Notice: Variation of Authorisation

Authorisation Number:	CAR/L/1010366
Authorised Person:	Mowi Scotland Limited SC138843 1st Floor Admiralty Park Admiralty Road Rosyth Fife KY11 2YW
Variation Number:	VAR04
Authorised Place:	Port na Mine (Etive 3) Marine Pen Fish Farm (MPFF)
Date of Notice:	21 August 2025
Effective Date of Variation:	21 August 2025
Details of Variation:	The authorisation is varied as specified in the Schedule attached.

Figure 1 Fish Pen Location

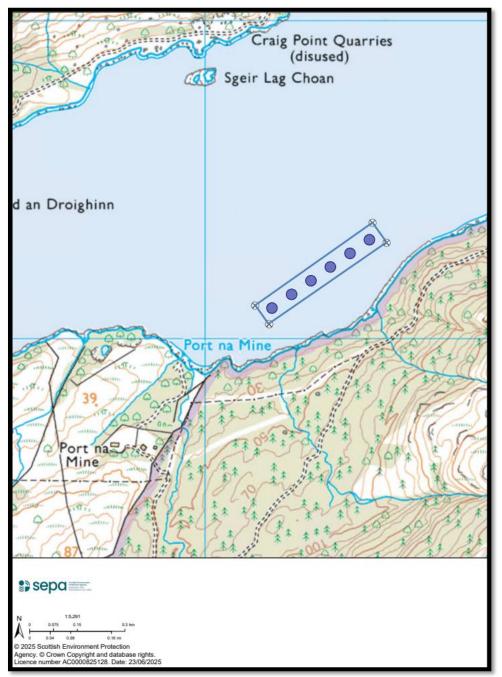
- **3.** Condition 2.4.2, together with Figure 1, have been deleted and replaced with a new condition 2.4.2 and a new Figure 1 as follows:
 - 2.4.2 The authorised location of the fish pen group is within an area delineated in Figure 1 and bounded by the pen corner buoys located at the following National Grid References (NGRs):
 - 1. NN 0320 3304 (S)
 - 2. NN 0315 3310 (W)
 - 3. NN 0352 3336 (N)
 - 4. NN 0357 3330 (E)
